**REBUTTAL TESTIMONY**

**TIM WOOLF**

**UNION ELECTRIC COMPANY D/B/A AMEREN MISSOURI**

**Case No. EO-2011-0271**

10 **Figure 1. Efficiency Savings as a Percent of Electricity Sales: UE versus Top 20 States<sup>2</sup>**

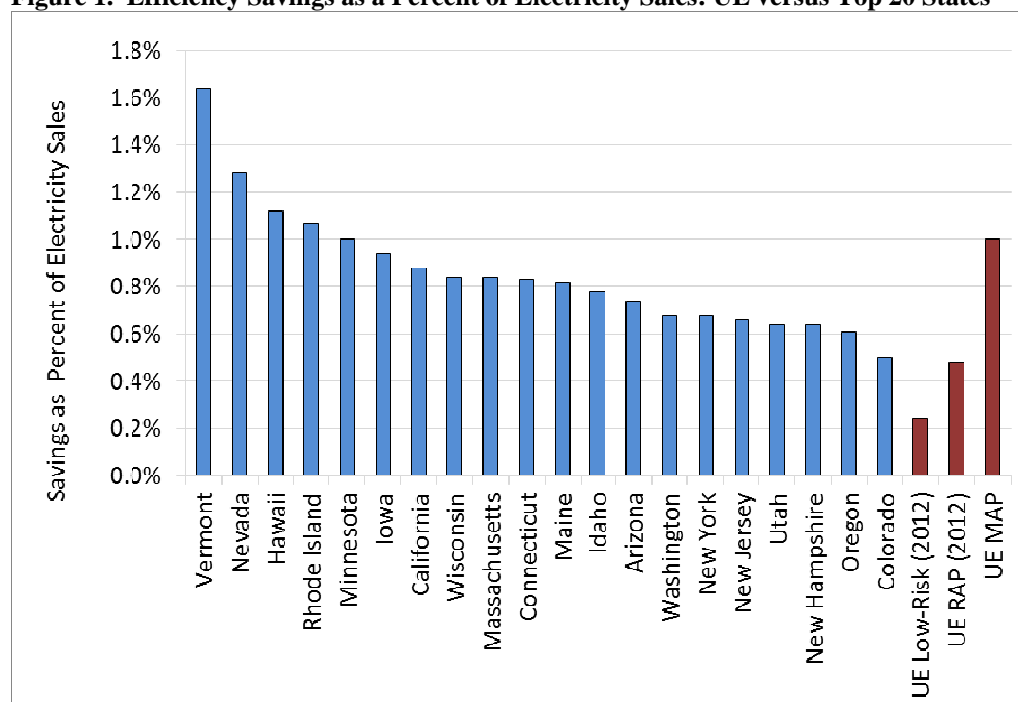
23 First, the Company uses relatively conservative assumptions to develop the RAP  
24 and Maximum Achievable Potential (MAP) scenarios. The RAP savings are  
25 limited by the Company's assumptions regarding customer incentives and  
26 customer awareness rates. (OPC Technical Report, pages 11 and 12.) The MAP  
27 savings are described as essentially the upper limit on what the Company could  
28 possibly save through energy efficiency programs. This portfolio assumes that  
29 the Company is able to achieve incrementally roughly one percent of annual

9 energy savings each year after 2015.<sup>1</sup> However, by 2009 five states have already  
 10 achieved efficiency savings equal to roughly one percent of annual sales per year,  
 11 and another 15 states have achieved efficiency savings of between 0.5 and 1.0  
 12 percent of annual energy savings per year. This is indicated in Figure 1 below.  
 13 The experience of other states suggests that the MAP scenario is not the  
 14 maximum that could potentially be achieved by the Company. It also suggests  
 15 that there is a lot more energy efficiency that could be reasonably achieved by the  
 16 Company beyond the amounts included in the RAP resource plan.

5 **Figure 2. Efficiency Program Budgets as Percent of Revenues: UE versus Top 20 States<sup>4</sup>**

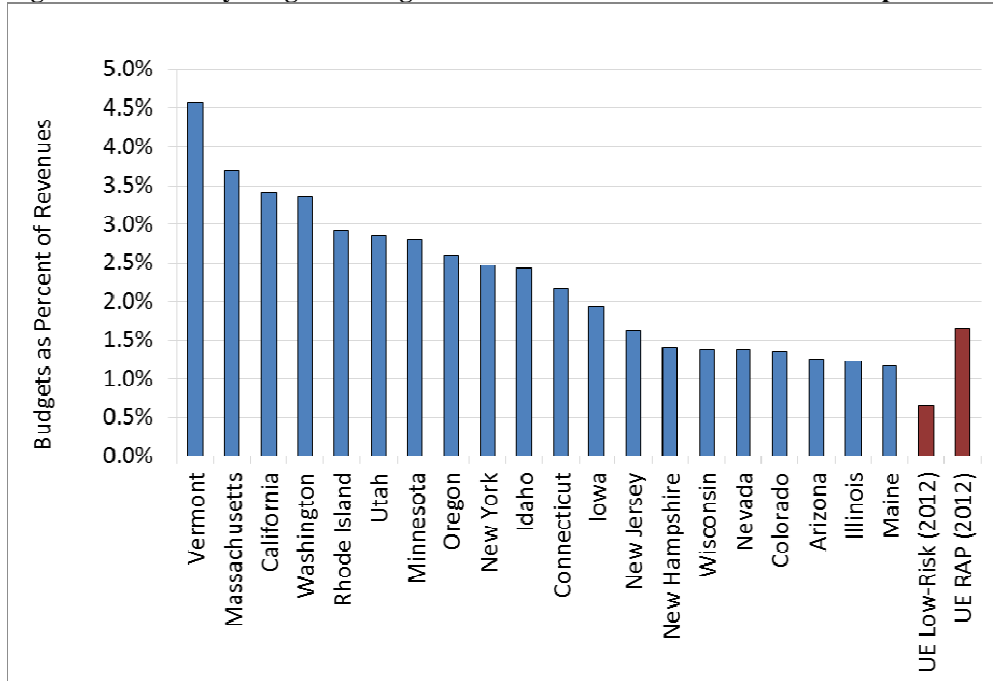
6  
15 It is instructive to compare the Company's proposed Low-Risk DSM budgets to  
16 the energy efficiency budgets that are currently being implemented by other  
17 electric utilities in the US. Figure 2 presents the 2010 annual electric energy  
18 efficiency budgets for the top 20 states, as a percentage of 2010 annual electric  
19 revenues. For comparison purposes it also presents the UE 2012 budgets for the  
20 Low-Risk and RAP scenarios, also as a percent of 2010 annual electric revenues.  
21 As indicated in the figure, the Low-Risk budgets are well below many of those of  
22 other states, and the RAP budget is also well below the budgets of some states as  
23 well.
